ERRATA for
PE Structural Engineering Practice Exam
ISBN 978-1-947801-17-2
Copyright 2021 (May 2021, first printing)
Errata posted 7/1/2022

Revisions are shown in red.

Question 103, Vertical Forces, p. 14

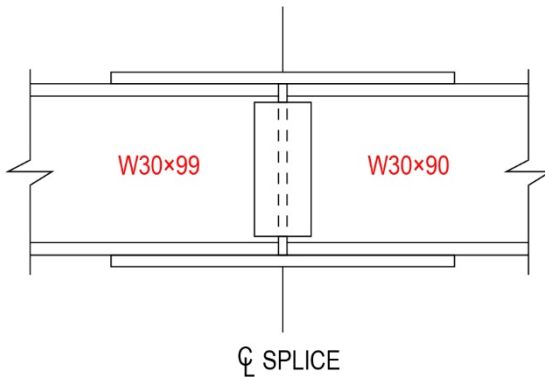
The options should read as follows:

- (A) 1.7
- (B) 2.5
- (C) **3.9**
- (D) 5.0
